**Proposed Late Revisions to the Proposed Basin
Plan Amendment documents for the Amendment
to the Water Quality Control Plan for the Tulare
Lake Basin to Remove the Municipal and
Domestic Supply (MUN) and Agricultural Supply
(AGR) Beneficial Uses from Groundwater Within
a Designated Horizontal and Vertical Area Within
and Surrounding the Administrative Boundaries
of the South Belridge, Monument Junction and
Cymric Oil Fields in Kern County Near
McKittrick, California**

**Regional Water Quality Control Board,
Central Valley Region Board Meeting
12 December 2025**

**LATE REVISIONS TO MCKITTRICK AREA OIL FIELDS BENEFICIAL USE
EVALUATION BASIN PLAN AMENDMENT DOCUMENTS – 12 DECEMBER 2025**

Figure 2-4: McKittrick Area Oil Fields Beneficial Use Exemption Area

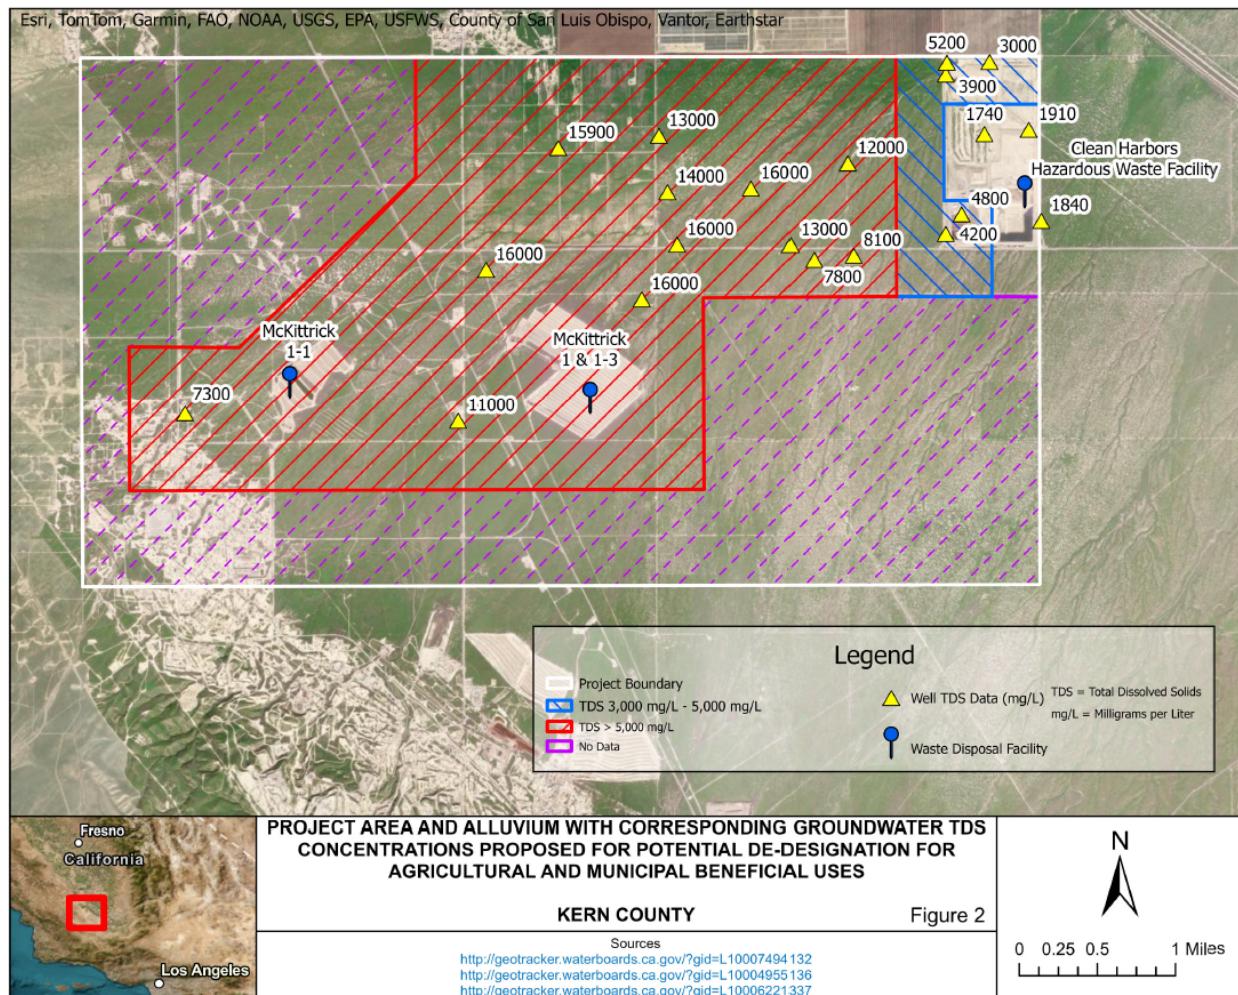
Modify Chapter 2 of the Basin Plan, adding a new row to the bottom of Table 2-3, thereby establishing an Exception Area 6 (column 1) with the following Area Description (column 2), which shall be applicable to Detailed Analysis Unit (DAU #) #259 (column 3); also Modify Chapter 2 of the Basin Plan by adding 'Figure 2-4, McKittrick Area Oil Fields Beneficial Use Exemption Area' to Chapter 2 of the Basin Plan, after 'Figure 2-3, Tulare Lake Bed Beneficial Use Exemption Area':

Groundwater contained within the Holocene Alluvium (alluvium) and Corcoran Clay Equivalent (CCE), from ground surface to the base top of the Corcoran Clay Equivalent (CCE), within the approximately 6.0-6.1-square-mile two-dimensional surface area horizontal extent detailed in the 'Revised

Project Area as shown in Figure 2-4; the horizontal extent that lies approximately within: composed of: the east quarter of Section 13, some of the south half of Section 13, the southeast quarter of Section 23, the east half of the southwest quarter of Section 23, some of the southeast quarter of the northeast quarter of Section 23, the south half and the east quarter and some of the north half of Section 24, the north quarter of Section 25, the north half of the northeast quarter of Section 26, and the northeast quarter of the northwest quarter of Section 26, of T29S/R21E, Mount Diablo Baseline and Meridian (MDBM)~~MDBM~~, and Sections 17, 18, and 19, the west quarter of Section 16, the west and north quarters of Section 20, the northwest quarter of the northwest quarter of Section 21, the northwest quarter of the northwest quarter of Section 29, and the north quarter of Section 30, of T29S/R22E, MDBM₁ is not suitable, or potentially suitable, for municipal or domestic supply (MUN) or agricultural supply (AGR), including, but not limited to, AGR applications for irrigation, stock watering and support of vegetation for range grazing.

Additionally, groundwater contained within the alluvium and CCE, from ground surface to the base of the CCE, with the a approximately half-0.5-square-mile two-dimensional surface area horizontal extent detailed in the 'Revised Project Area' as shown in Figure 2-4; the horizontal extent that lies approximately within: composed of: the north half of the northeast quarter of Section 16, the east half of the west half of Section 16, the southwest quarter of the southeast quarter of Section 16, the northeast quarter of the northwest quarter of Section 21, and the northwest quarter of the northeast quarter of Section 21, of T29S/R22E, MDBM₁ is not suitable, or potentially suitable, for municipal or domestic supply (MUN).

Red hashed area is de-designated for municipal or domestic supply (MUN) or agricultural supply (AGR). Blue hashed area is de-designated for municipal or domestic supply (MUN) only.

a. Page 63 - Figure 2:

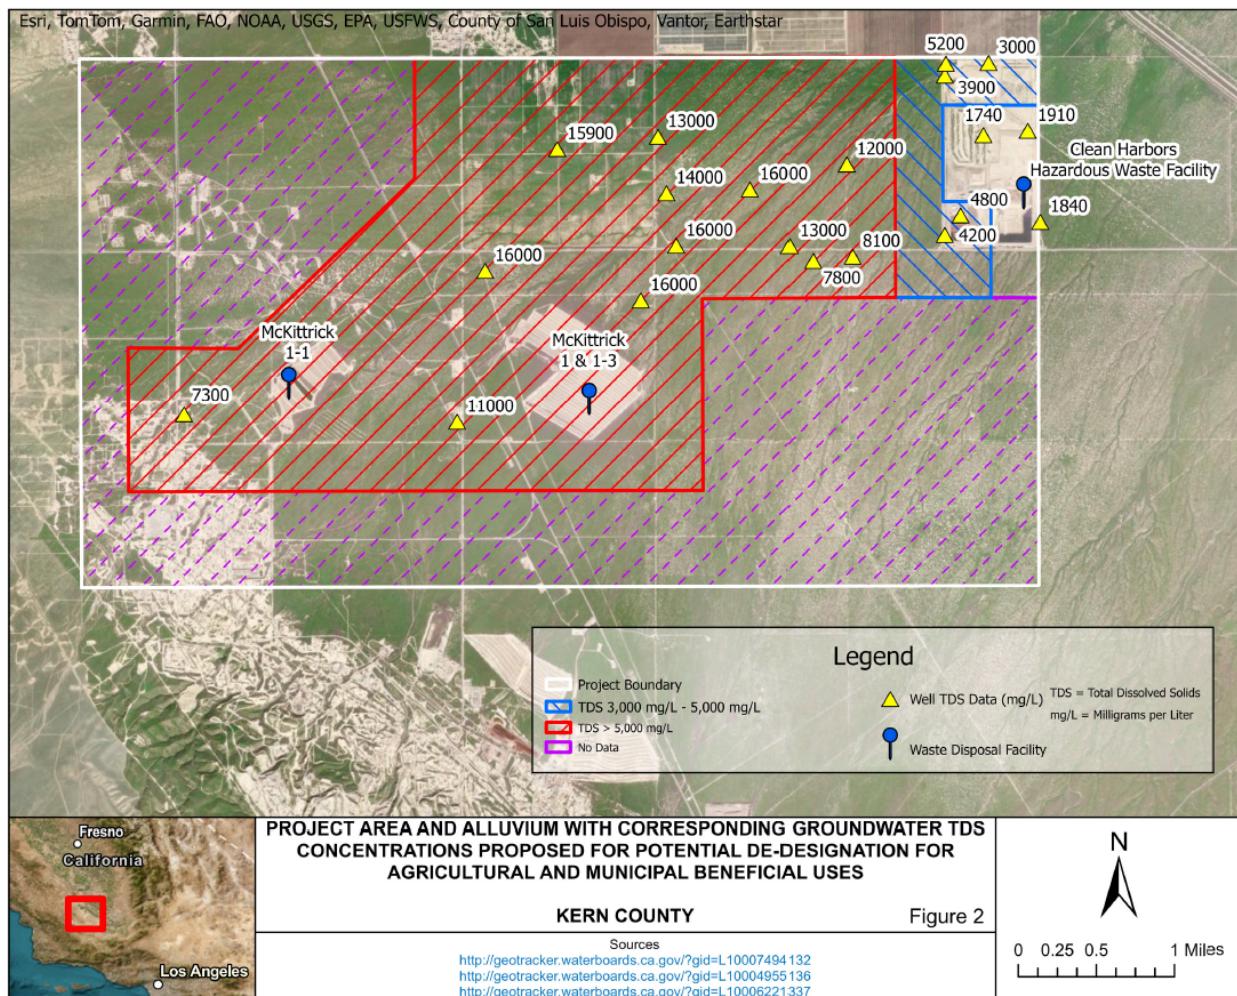
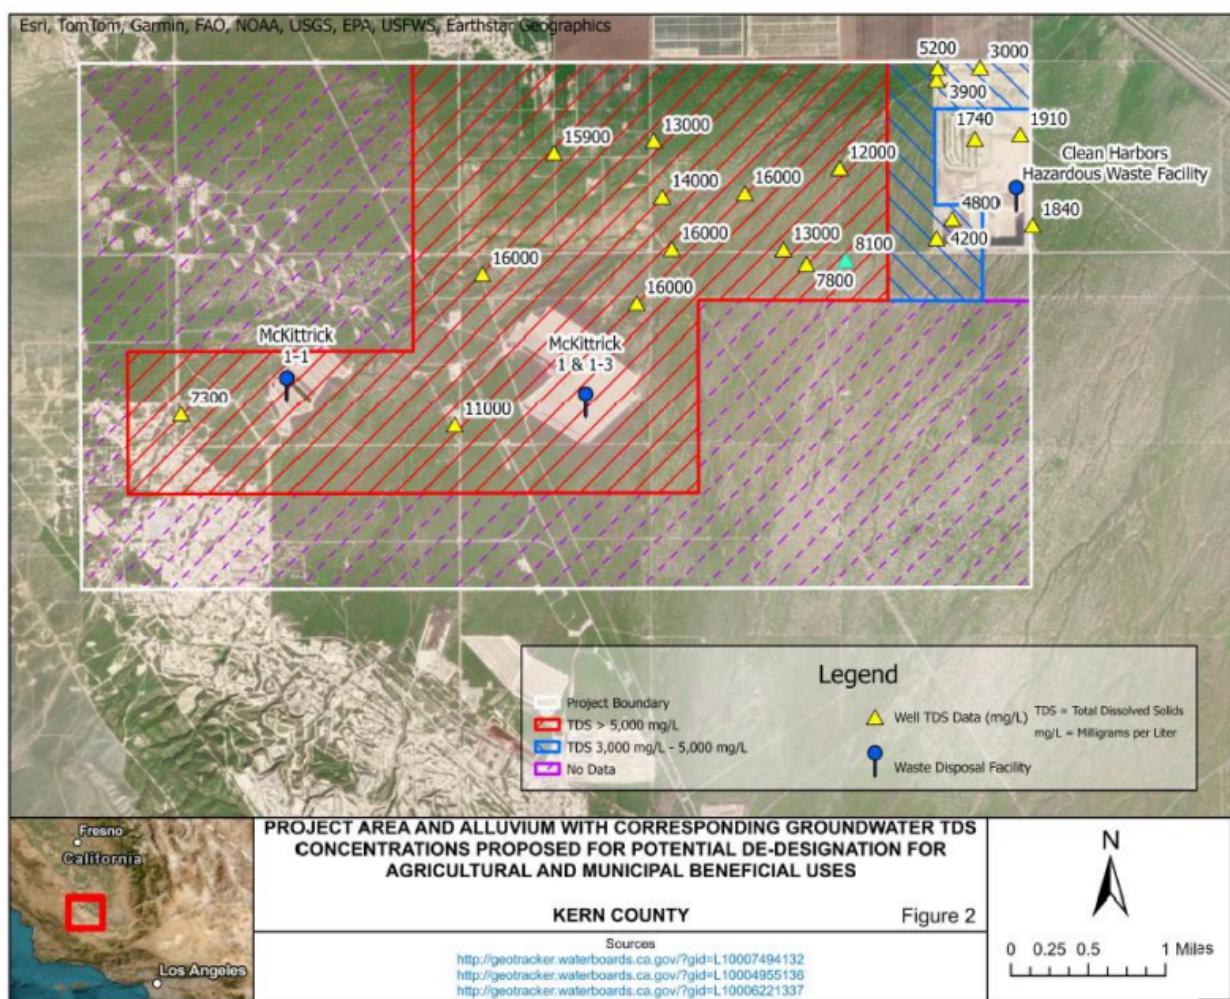
- Remove the following Figure 2 image located above the caption for Figure 2:

ii. Add the following Revised Figure 2 image above the caption for Figure 2, in place of the deleted Figure 2 image above:

Figure 2. Project Area showing the whole area considered for de-designation (white box), area where alluvium-groundwater above the base of the CCE exceeds 5,000 mg/L TDS (red box/hashed area – Revised Project Area proposed for de-designation for both MUN and AGR beneficial uses), area where alluvium-groundwater above the base of the CCE is between 3,000 and 5,000 mg/L (blue box/hashed area – Revised Project Area proposed for de-designation of only MUN beneficial use), and area where there is no data for groundwater in the alluvium above the base of the CCE (purple box/hashed area).

Figure 2-4: McKittrick Area Oil Fields Beneficial Use Exemption Area

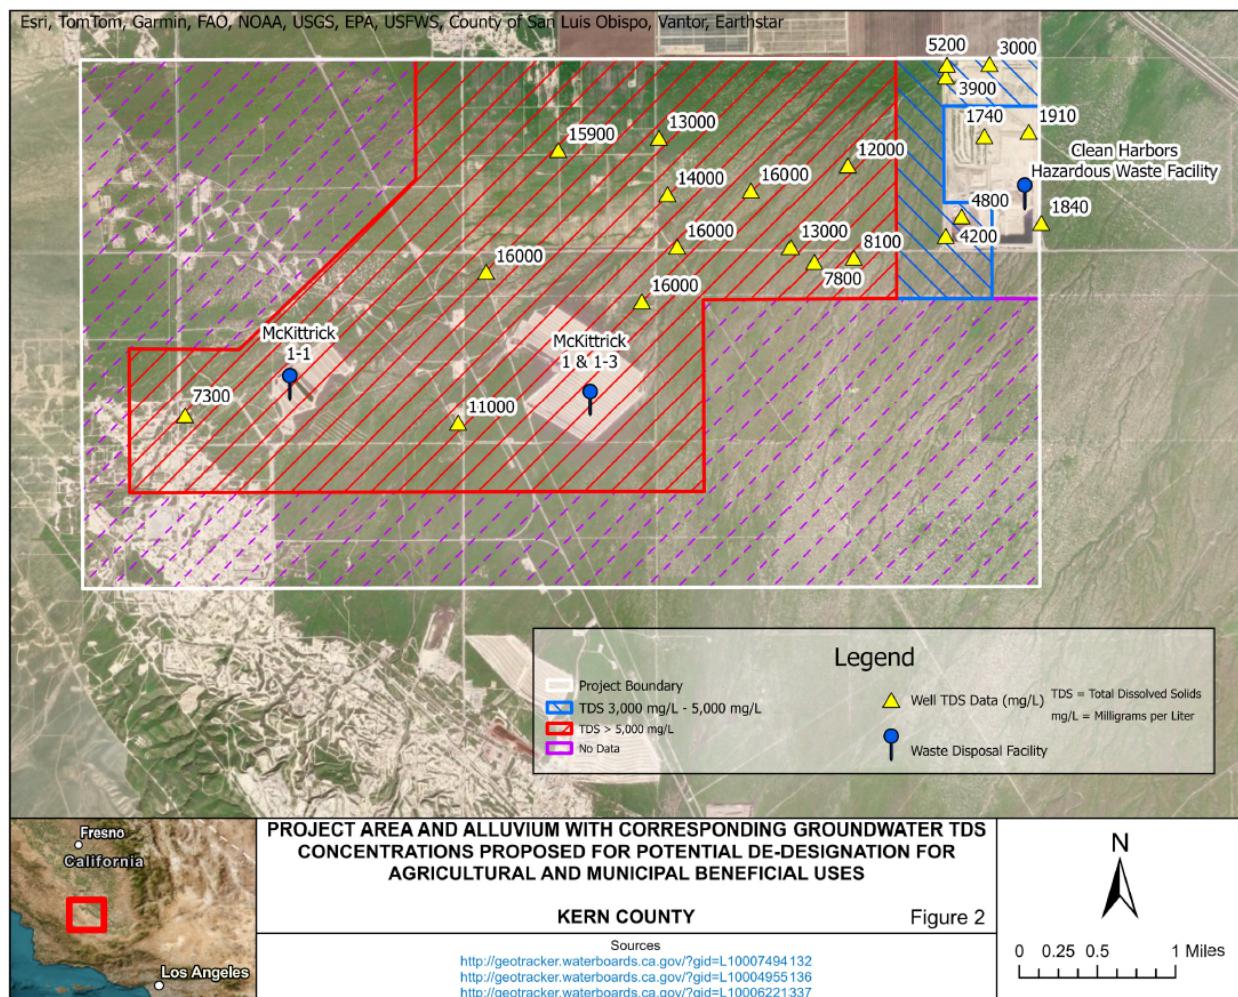
Modify Chapter 2 of the Basin Plan, adding a new row to the bottom of Table 2-3, thereby establishing an Exception Area 6 (column 1) with the following Area

Description (column 2), which shall be applicable to Detailed Analysis Unit (DAU #) #259 (column 3); also Modify Chapter 2 of the Basin Plan by adding 'Figure 2-4, McKittrick Area Oil Fields Beneficial Use Exemption Area' to Chapter 2 of the Basin Plan, after 'Figure 2-3, Tulare Lake Bed Beneficial Use Exemption Area':

Groundwater contained within the Holocene Alluvium (alluvium) and Corcoran Clay Equivalent (CCE), from ground surface to the base top of the Corcoran Clay Equivalent (CCE), within the approximately 6.0-6.1-square-mile two-dimensional surface area horizontal extent detailed in the 'Revised Project Area' as shown in Figure 2-4; the horizontal extent that lies approximately within: composed of: the east quarter of Section 13, some of the south half of Section 13, the southeast quarter of Section 23, the east half of the southwest quarter of Section 23, some of the southeast quarter of the northeast quarter of Section 23, the south half and the east quarter and some of the north half of Section 24, the north quarter of Section 25, the north half of the northeast quarter of Section 26, and the northeast quarter of the northwest quarter of Section 26, of T29S/R21E, Mount Diablo Baseline and Meridian (MDBM) MDBM, and Sections 17, 18, and 19, the west quarter of Section 16, the west and north quarters of Section 20, the northwest quarter of the northwest quarter of Section 21, the northwest quarter of the northwest quarter of Section 29, and the north quarter of Section 30, of T29S/R22E, MDBM. is not suitable, or potentially suitable, for municipal or domestic supply (MUN) or agricultural supply (AGR), including, but not limited to, AGR applications for irrigation, stock watering and support of vegetation for range grazing.

Additionally, groundwater contained within the alluvium and CCE, from ground surface to the base of the CCE, with the a approximately half-0.5-square-mile two-dimensional surface area horizontal extent detailed in the 'Revised Project Area' as shown in Figure 2-4; the horizontal extent that lies approximately within: composed of: the north half of the northeast quarter of Section 16, the east half of the west half of Section 16, the southwest quarter of the southeast quarter of Section 16, the northeast quarter of the northwest quarter of Section 21, and the northwest quarter of the northeast quarter of Section 21, or of T29S/R22E, MDBM. is not suitable, or potentially suitable, for municipal or domestic supply (MUN).

Red hashed area is de-designated for municipal or domestic supply (MUN) or agricultural supply (AGR). Blue hashed area is de-designated for municipal or domestic supply (MUN) only.

a. Page D-55 – Figure 2

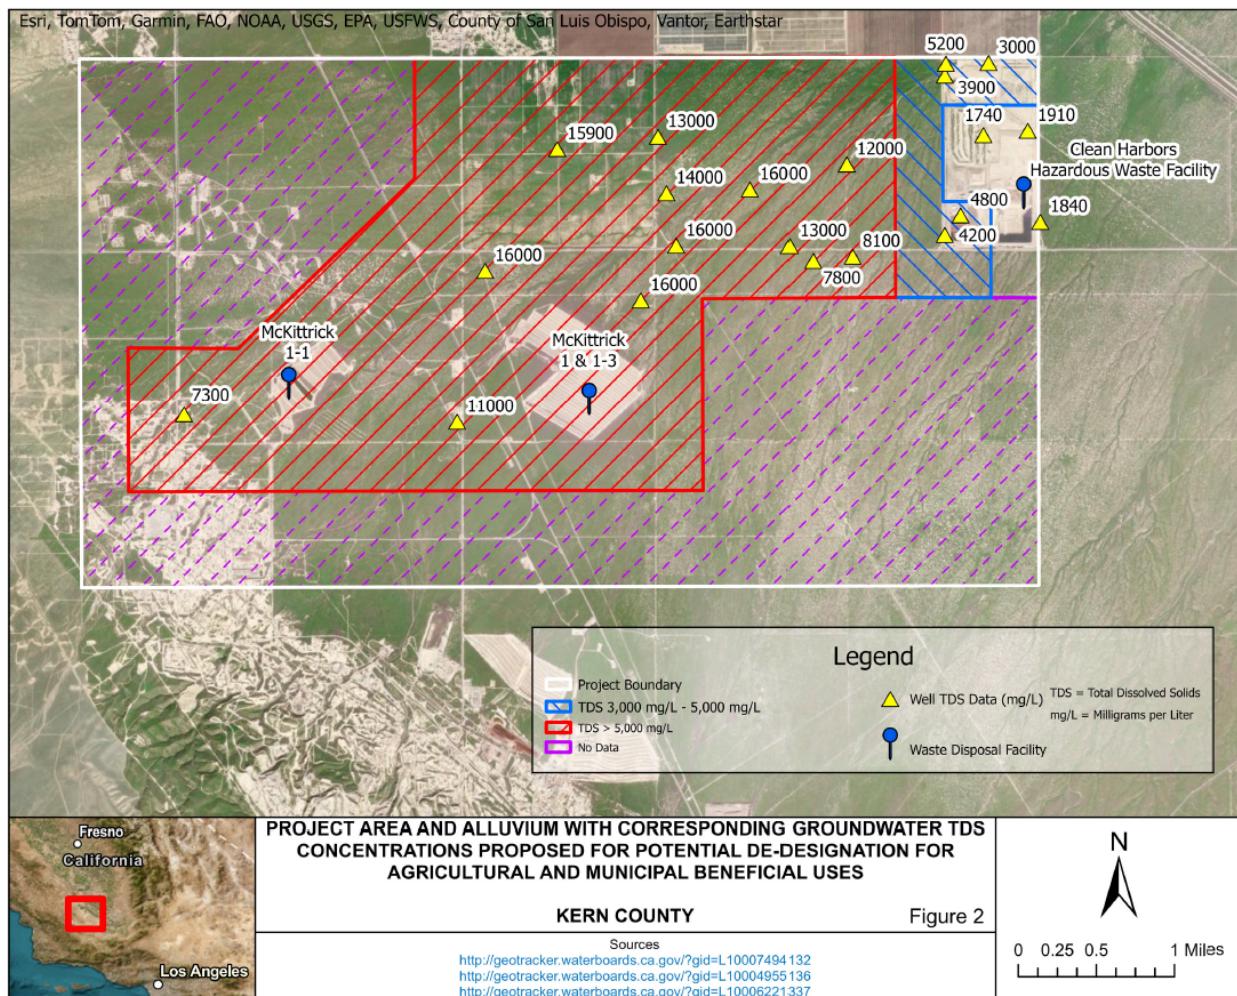
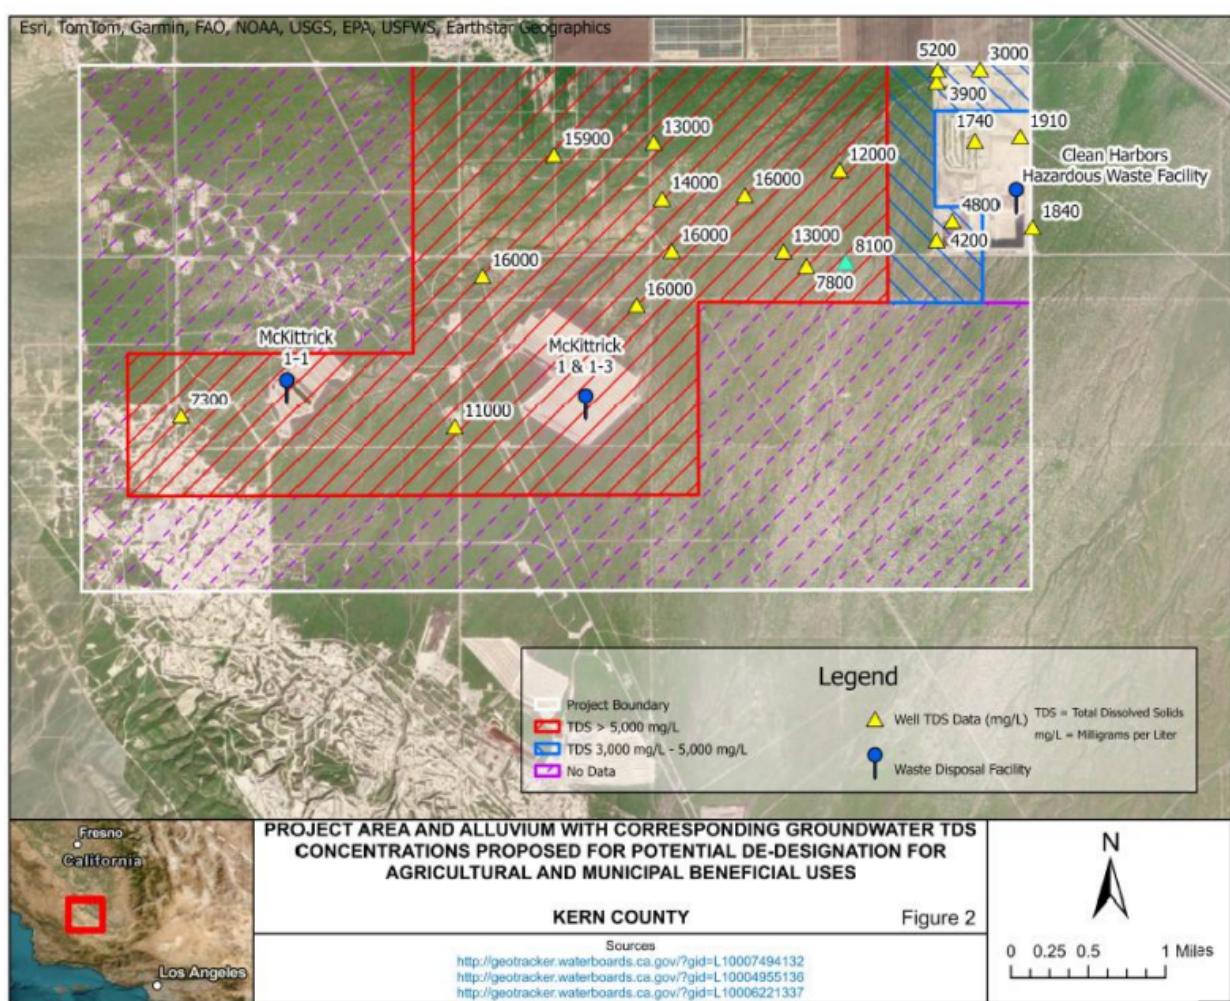
i. Remove the following Figure 2 image located above the caption for Appendix D Figure 2:

ii. Add the following Revised Figure 2 image above the caption for Appendix D Figure 2, in place of the deleted Figure 2 image above:

Figure 2. Project Area showing the whole area considered for de-designation (white box), area where alluvium-groundwater above the base of the CCE exceeds 5,000 mg/L TDS (red box, hashed – Revised Project Area proposed for de-designation for both MUN and AGR beneficial uses), area where alluvium-groundwater above the base of the CCE is between 3,000 and 5,000 mg/L (blue box, hashed area – Revised Project Area proposed for de-designation of only MUN beneficial use), and area where there is limited or no water quality data for groundwater in the alluvium above the base of the CCE (purple box, hashed area).
